**Written submission from
Paul Sedran, RESD Inc.**

Application to extend the operation of
Pickering Nuclear Generating Station
Units 5 to 8 until December 31, 2026

Commission Public Hearing

Review of the Operation of PNGS to 2026, the
 Technical Issue of Partial Nip-Up of the Spacer
 and the Calandria Tube

Figure 1
ID Profiles from the CT Removed from Fuel Channel P4 M11

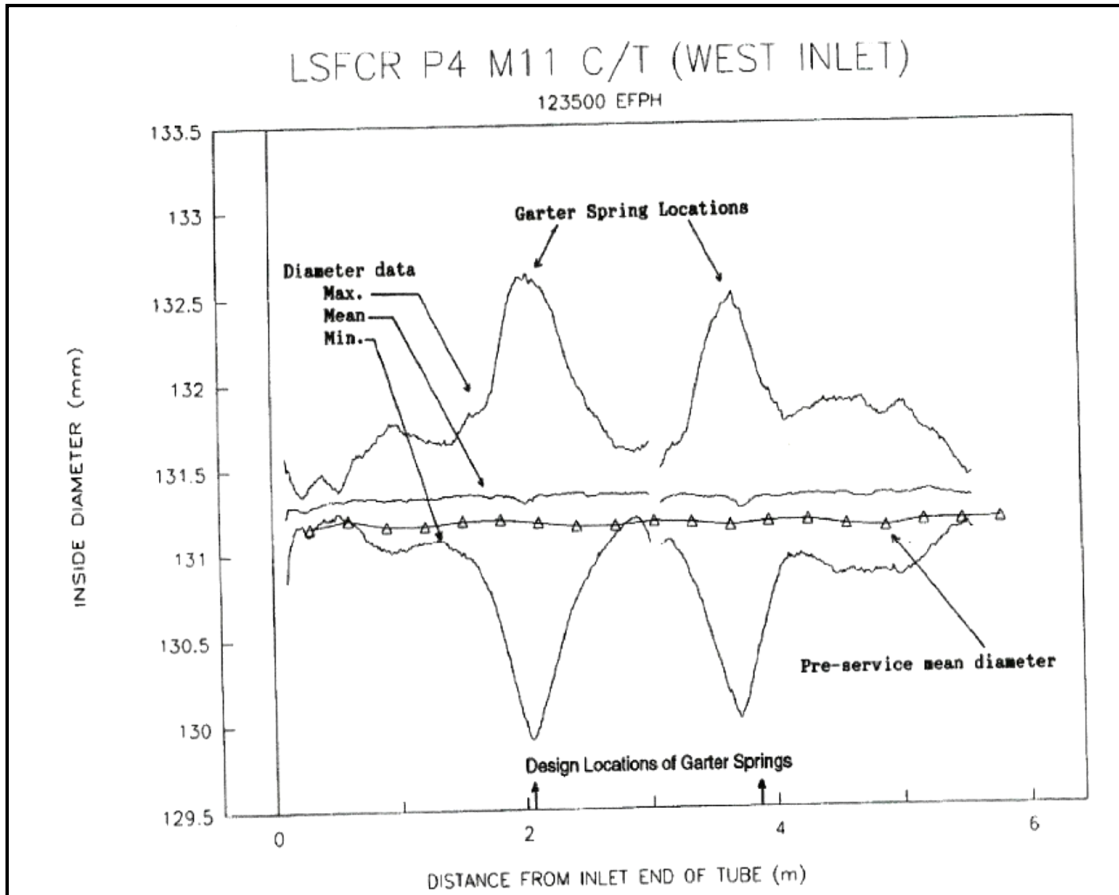
Figure 1 (from Reference 5) provides plots of axial profiles for the minimum, mean, and maximum ID values, for the CT removed from P4 M11 at 123,500 EFPH. For the spacer location at 2 m, it was found that the horizontal ID of the CT had contracted at a rate of 0.0105 mm/kEFPH.

The data from Figure 1 was used to generate the following linear model for the horizontal CT ID (at the 2 m location) versus time in-service, for use in Figure 3:

Figure 2
Plot of PT ID versus Axial Position

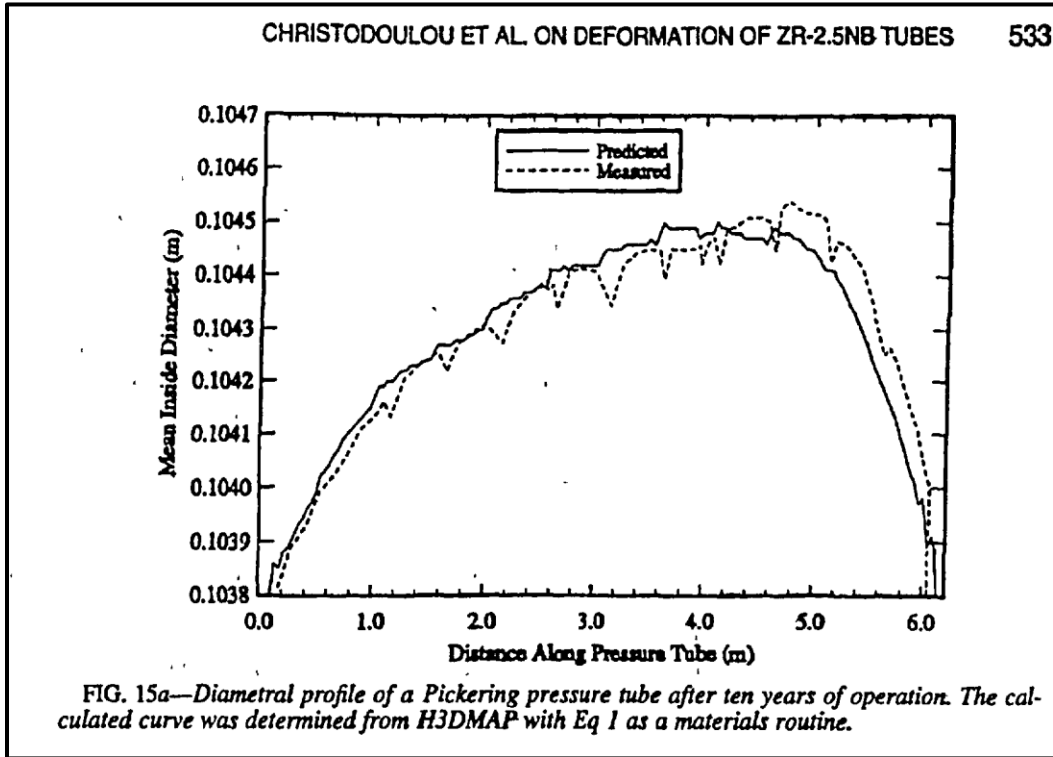
Figure 2 is plot of the ID of a typical PT from PNGS, from Reference 6. At the time of the measurements, the PT had been in service for 10 years or approximately 70 kEFPH. From Figure 2, the rate of diametral expansion of the PT, at the 2 m location, was found to be 0.007 mm/kEFPH. The above rate of diametral expansion was ascribed to the horizontal outer diameter of the spacer annulus on the outside of the PT at the 2 m location in P4 M11.

The data from Figure 2 was used to generate the following linear model for the horizontal OD of the Spacer Annulus (at the 2 m location) versus time in-service:

Figure 3
Plot of the Horizontal ID of the CT and the Horizontal OD
of the Spacer Annulus at the 2 m location in P4 M11

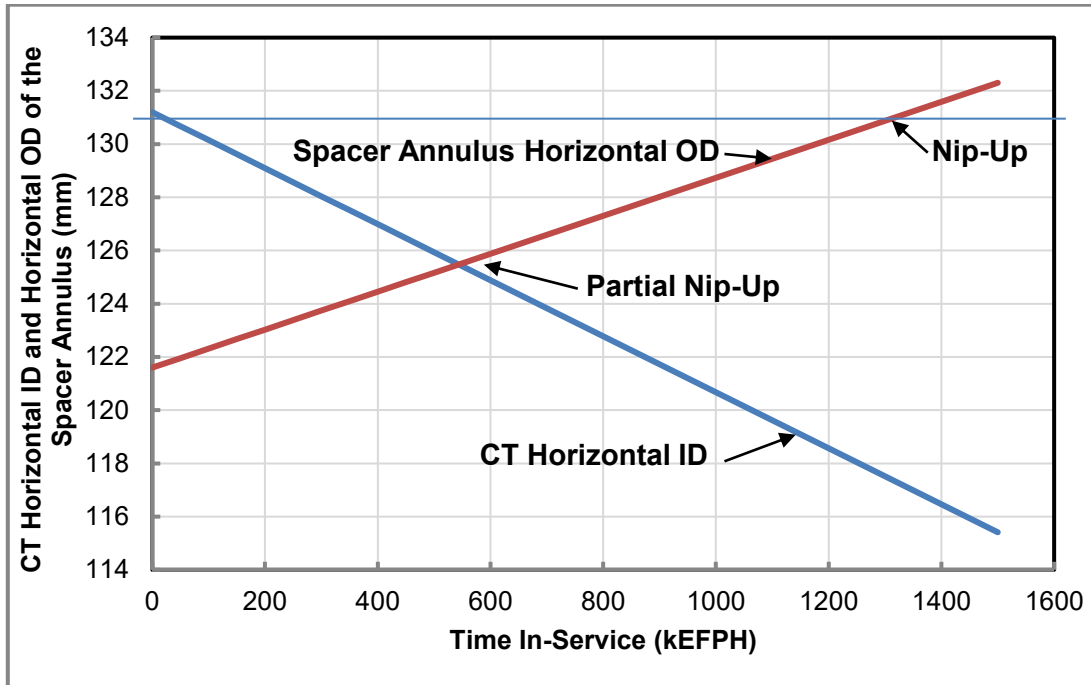
In Figure 3, Nip-Up, which assumes no deformation of the CT, is predicted to occur at 1300 KEFP.

Also, as seen in Figure 3, Partial Nip-Up is predicted to occur at an earlier time than Nip-Up, at about 550 KEFP. The earlier onset of Partial Nip-Up is expected, because the Partial Nip-Up analysis accounts for both the deformation of the CT and the PT, while the Nip-Up analysis accounts only for PT diametral expansion.

It should be noted that Figure 3 is not a good example of Nip-Up and Partial Nip-Up because the onset times are very far above the operating life of the Fuel Channels. However, Figure 3 demonstrates clearly that with CT ovalisation, all Fuel Channels will encounter Partial Nip-Up significantly earlier than the Nip-Up condition.

Over time, in the current Nip-Up analysis, with no ovalisation of the CT assumed, the interactions of the PT, the Spacer, and the CT, would be different than the actual interactions, once Partial Nip-Up starts. Once Partial Nip-Up starts, temperature and stress distributions in

the PT, CT, (at Spacer locations) and in the Spacer will be different than those in the current Spacer Nip-Up analyses, with no ovalisation of the CT assumed.

1. Based on an independent review of the 3 documents listed in Section 2.1, the author concurs that the PNGS Fuel Channels are fit-for-service for operation to the end of 2026.
2. With ovalisation of the CT at spacer locations, with time in-service, Partial Nip-Up of the spacer and CT will occur earlier than Nip-Up, but is not expected to be an issue for Fuel Channel fitness-for-service.
3. To date, it is believed that the Partial Nip-Up condition has not been included in the Pickering Fuel Channel Stress Report but should be assessed for possible inclusion in the Report.
